UNITED STATES PATENT AND TRADEMARK OFFICE

APPLICATION NO.	FILING DATE	FIRST NAMED INVENTOR	ATTORNEY DOCKET NO.	CONFIRMATION NO.
10/059,311	01/31/2002	Kyung Chul Woo	3449-0190P	5488
2292	7590	08/06/2004	EXAMINER	
BIRCH STEWART KOLASCH & BIRCH PO BOX 747 FALLS CHURCH, VA 22040-0747			JAGAN, MIRELLYS	
			ART UNIT	PAPER NUMBER
			2859

Office Action Summary	Application No. 10/059,311	Applicant(s) WOO ET AL.	
	Examiner Mirellys Jagan	Art Unit 2859

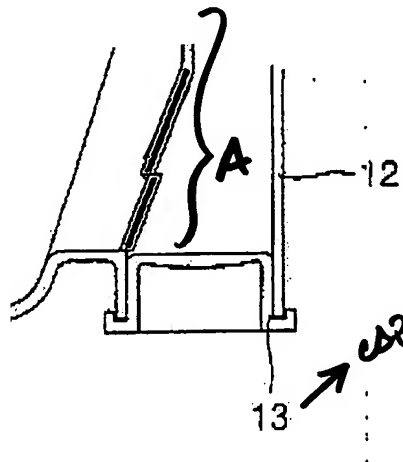
There is lack of antecedent basis in the original disclosure for the cap overlapping the tapered portion of the outer tub, as claimed in claims 5 and 9 (see figure 1(b) below, for example, which shows that the hollow cap does not overlap the tapered portion (A) of the outer tub).

Claim 6 is objected to for being dependent on objected base claim 5. Appropriate correction is required.

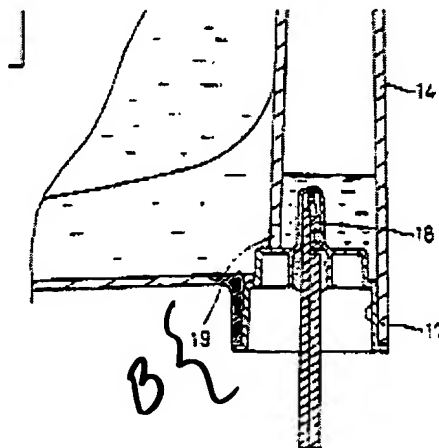
a water temperature measuring part including a temperature sensor (18) and signal lines for connecting the sensor to a circuit for measuring a temperature of water;

a water gauge chamber (14) extending along an outer side of an outer edge of an outer tub (2) of the washing machine; and

a hollow chamber cap (17) that is located at a bottom edge of the water gauge chamber to close an opened bottom portion of the gauge chamber, the cap having an upper side that is substantially flat, wherein substantially an entire upper surface of the of the upper side is exposed to the water;

wherein a lower surface of the upper side is formed with a recess serving as a seating portion in which is mounted the temperature measuring part so that the temperature of the water is measured without the sensor directly contacting the water; a hollow space of the cap faces downward and the water in the gauge chamber is above the cap; and a lower portion (labeled B in figure 3 shown below) of a side of the outer tub is tapered inwardly toward a bottom of the outer tub such that the cap overlaps the portion tapered inwardly (see figures 2 and 3).

Furthermore, the term “substantially” is considered to be a relative term, and since the specification does not provide a standard for ascertaining the requisite degree, the upper side of the cap disclosed by Yamamoto is considered to be substantially flat and have a substantially entire upper surface exposed to the water.
